Service Action Circular

Subject: 2004 Model Year Volkswagen Touareg Vehicles Modify Rubber Around Power Steering Fluid Line and Transmission Fluid Line Located Behind Radiator Grille

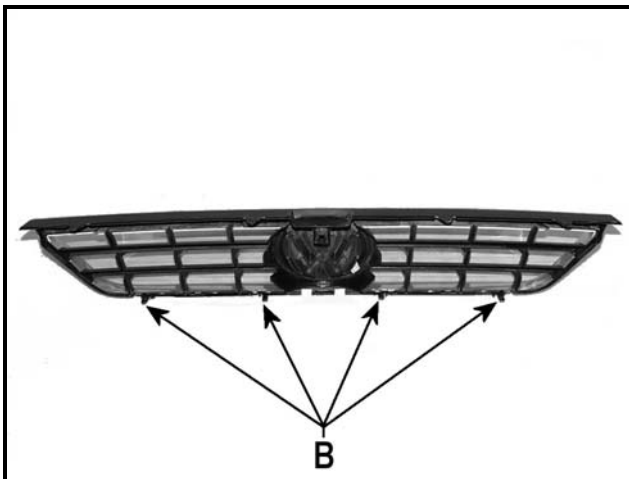
⇐ Remove screw -2-

Note: Screw -2- is accessed by going through upper hole in the emblem

⇐ Push down tabs -arrow A- using openings in the radiator support cover

⇐ Lift up tabs -arrow B- on the bottom of the grille and remove grille -1- from the vehicle

Note: Tabs -B- can be accessed through lower opening of the grille

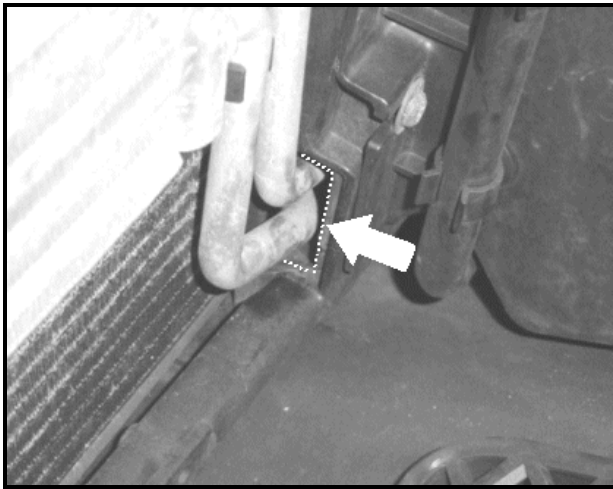
⇐ Illustration shows back side of grille and location of lower tabs -B-

⇐ At left bottom corner of radiator, use a small knife and carefully cut away the rubber contacting the power steering fluid lines

IMPORTANT! Only cut away rubber contacting the fluid lines from the area inside dotted lines -arrow-

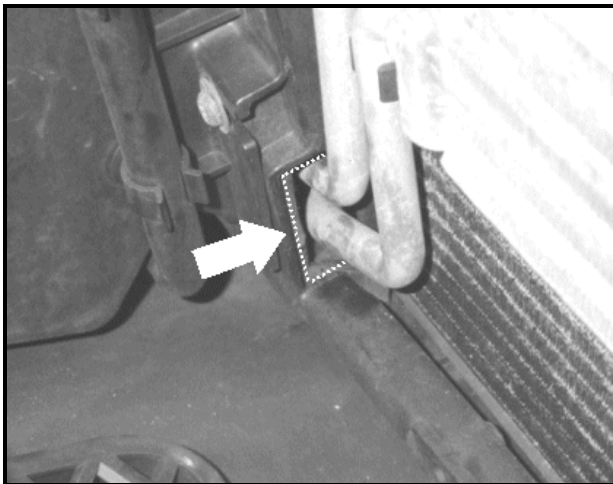
CAUTION: DO NOT DAMAGE RADIATOR OR FLUID LINE WHEN REMOVING RUBBER

⇐ At right bottom corner of radiator, use a small knife and carefully cut away the rubber contacting the automatic transmission fluid lines

IMPORTANT! Only cut away rubber contacting the fluid lines from the area inside dotted lines -arrow-

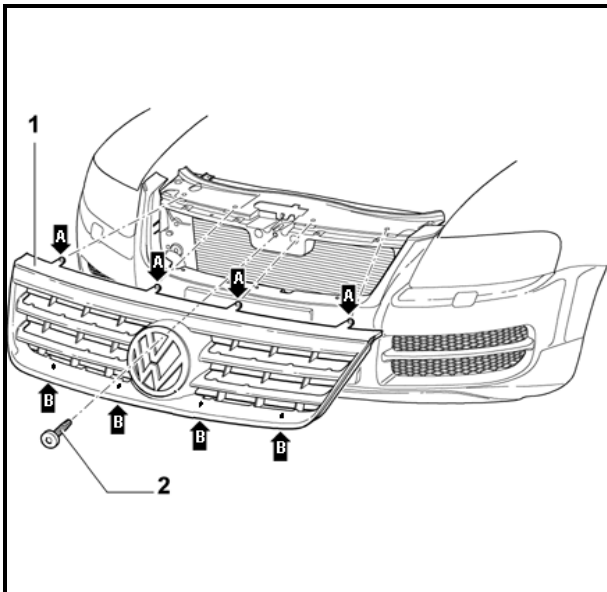
CAUTION: DO NOT DAMAGE RADIATOR OR FLUID LINE WHEN REMOVING RUBBER

⇐ Reinstall radiator grille -1- by sliding into position until tabs along the top -arrow A- and tabs along the bottom -arrow B- snap into position

⇐ Secure radiator grille with screw -2- and tighten to 1.5 Nm (13 in. lbs.)
